AGENDA
PLANNING COMMISSION MEETING
Chesterfield City Hall
690 Chesterfield Parkway West
Monday, August 10, 2026
7:00 PM

Planning Commission Staff Report

Description: **Hilltown Village Lot 2 (Good Clean Dog):** An Amended Site Development Section Plan, Landscape Plan, Lighting Plan, and Amended Architectural Elevations for part of a 2.56-acre tract of land located at the intersection of Hilltown Village Center and Olive Boulevard.

AMENDED SITE DEVELOPMENT
SECTION PLAN FOR LOT 2 OF HILLTOWN
VILLAGE SUBDIVISION

6.25.2026
A.61
ELEVATIONS

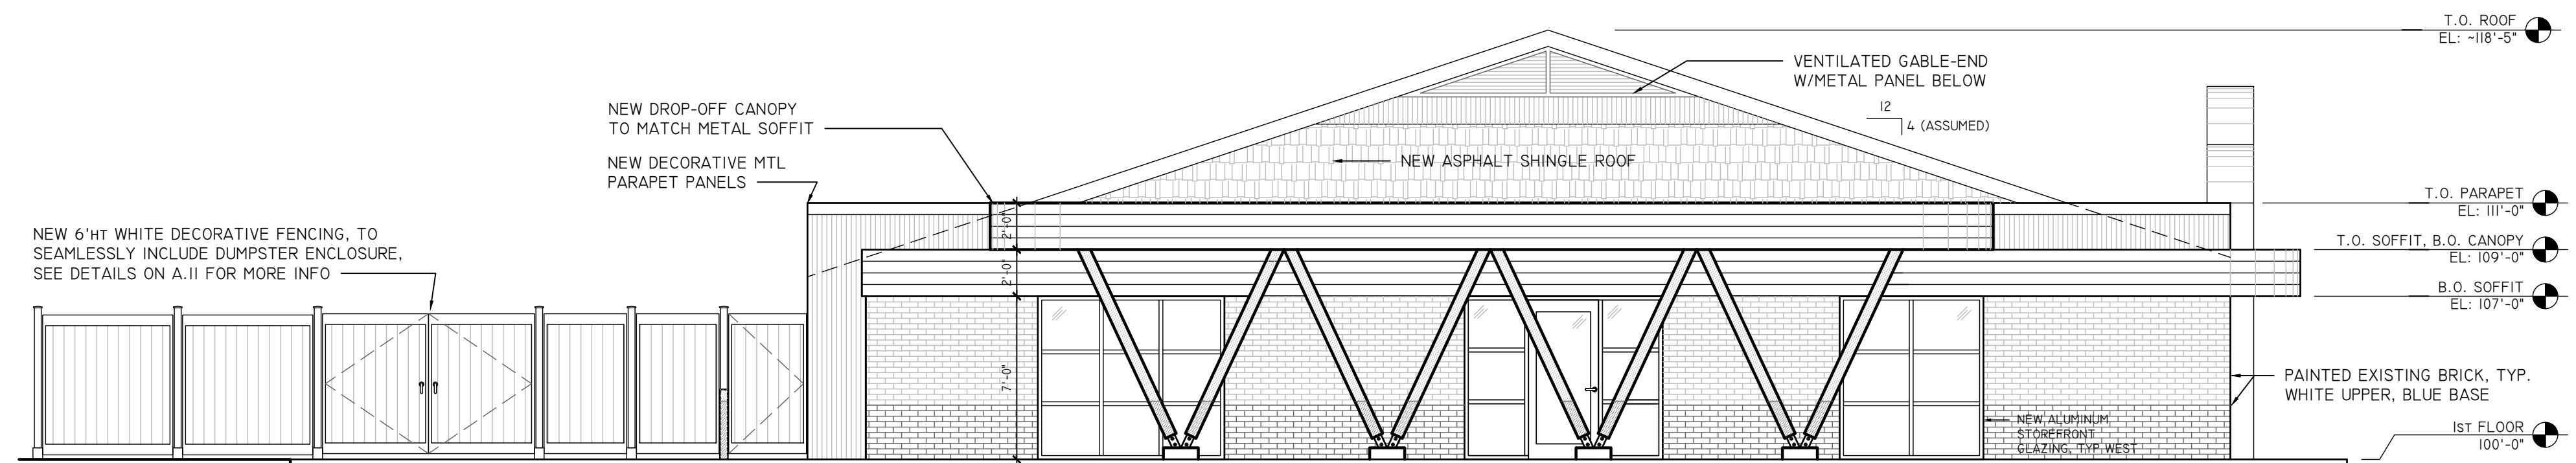
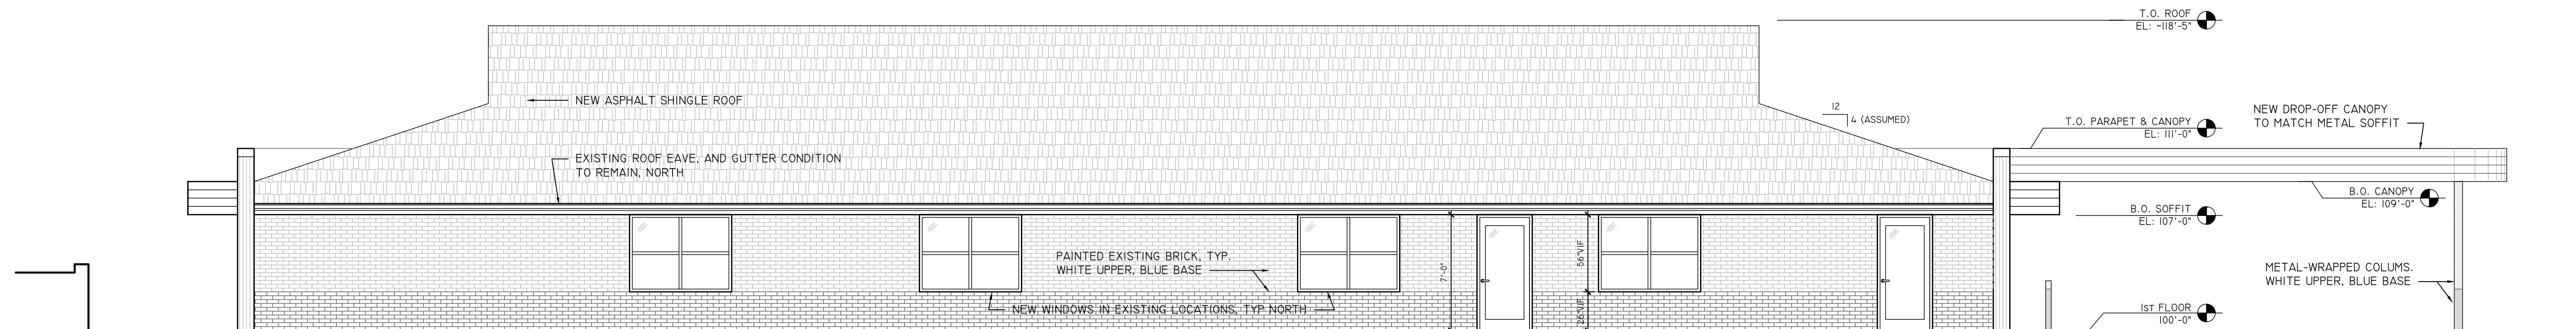
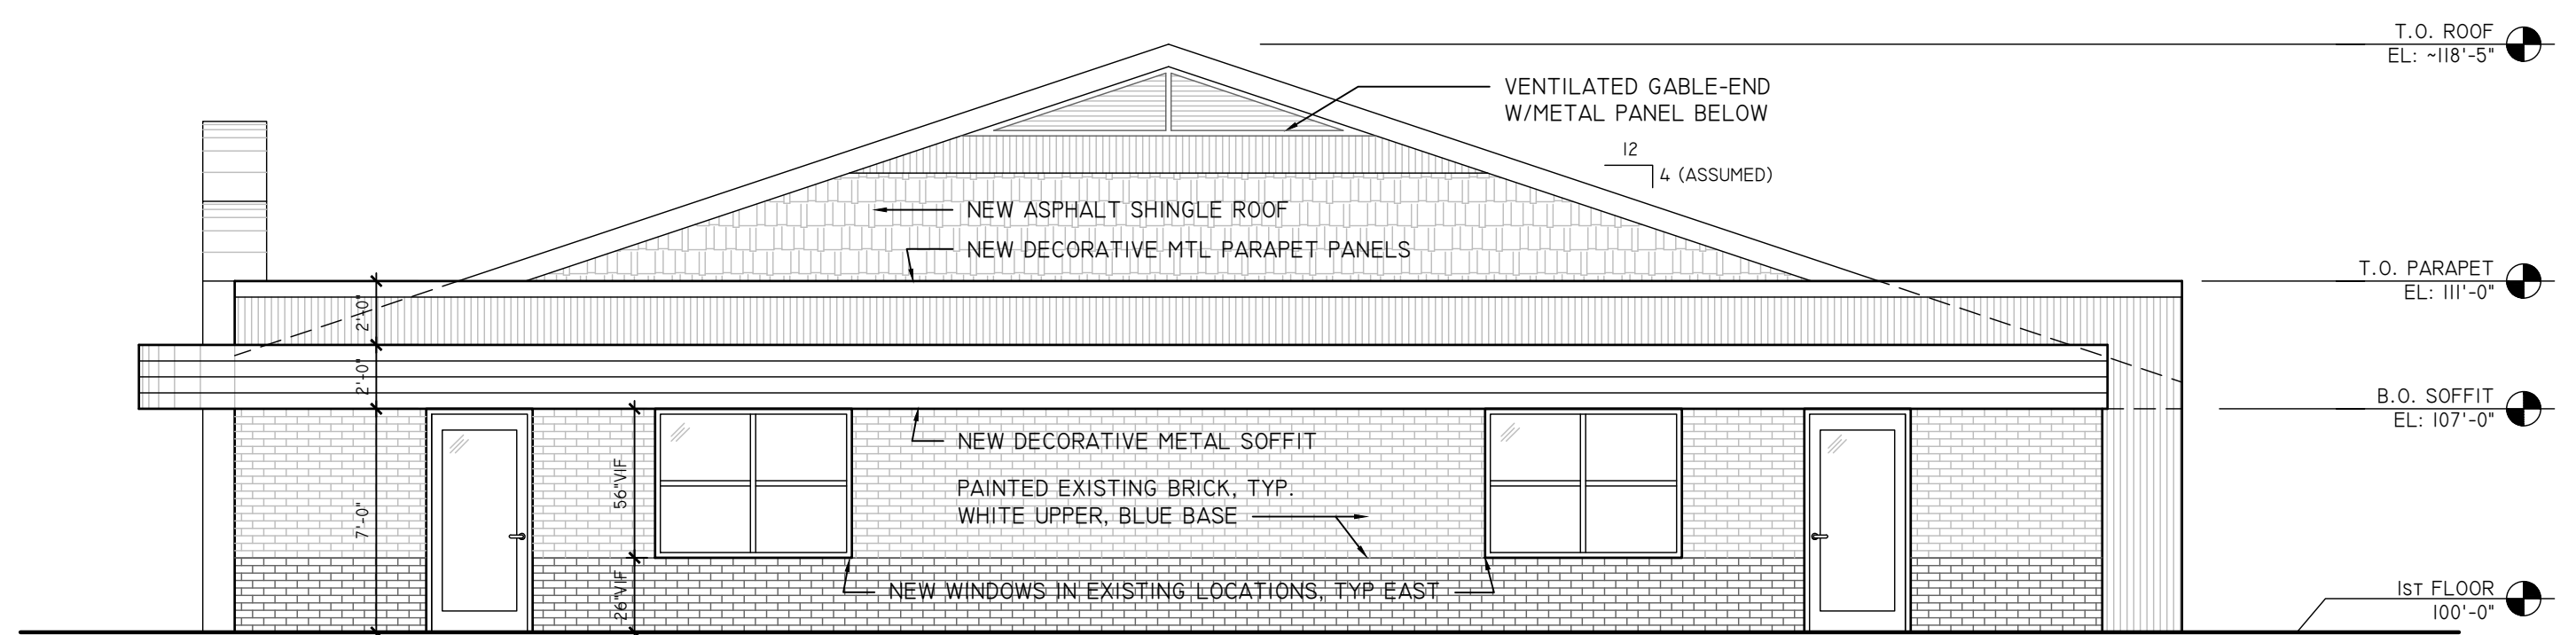
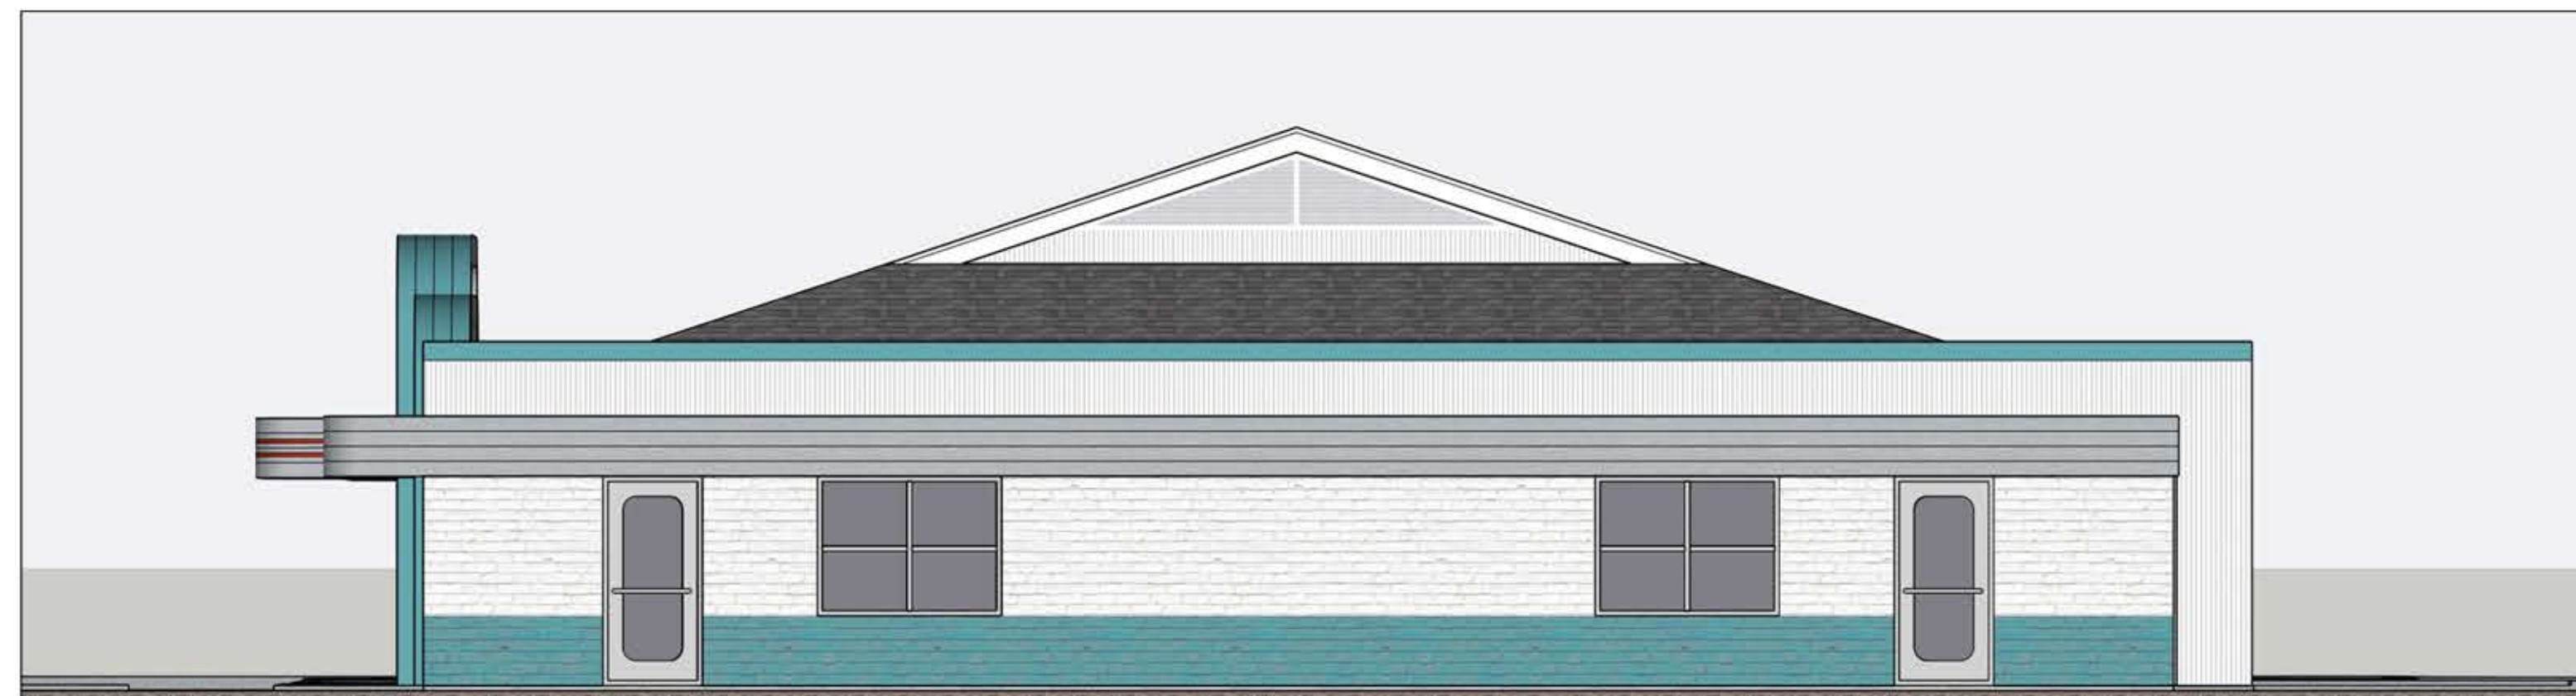
1. Change the roof shingle material color to a grayer or cooler tone.
2. Provide City Hall with additional color and material samples not presented to the ARB (glass, colored metal coping, colored treated metal, etc.).

The applicant has since submitted revised architectural elevations depicting the change in roof shingle color to Estate Gray, and additional exterior material samples were dropped off for ARB review the week following the meeting. Upon review, the ARB had no objections to the proposed changes and additional samples.

1 SOUTH ELEVATION
SCALE: $\frac{3}{16}" = 1'-0"$

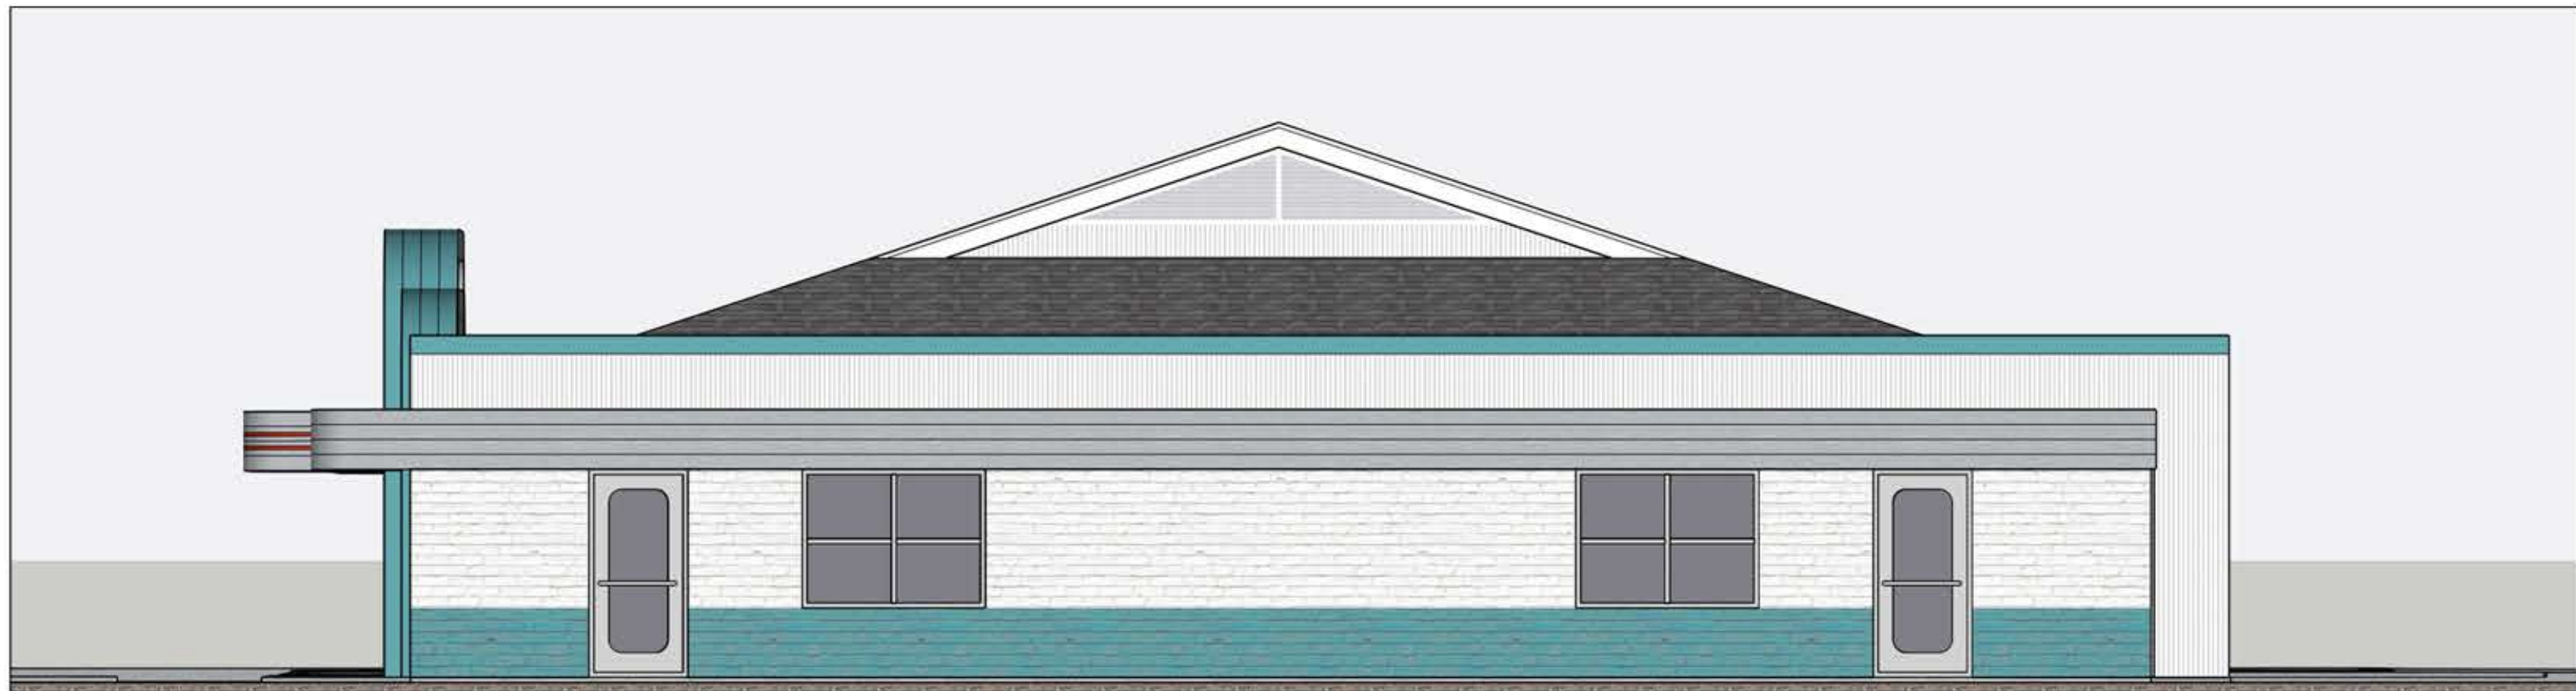
1. Remove the red LED rope lighting from the rear of the building facing the residential subdivision.
2. Provide updated nighttime renderings that reflect the full design, including the murals and graphics.

The applicant has since submitted revised elevations depicting the change in the rope lighting around the canopy, and provided a nighttime rendering depicting the murals and graphics. Upon review, the ARB had no objections to the proposed changes and additional samples.
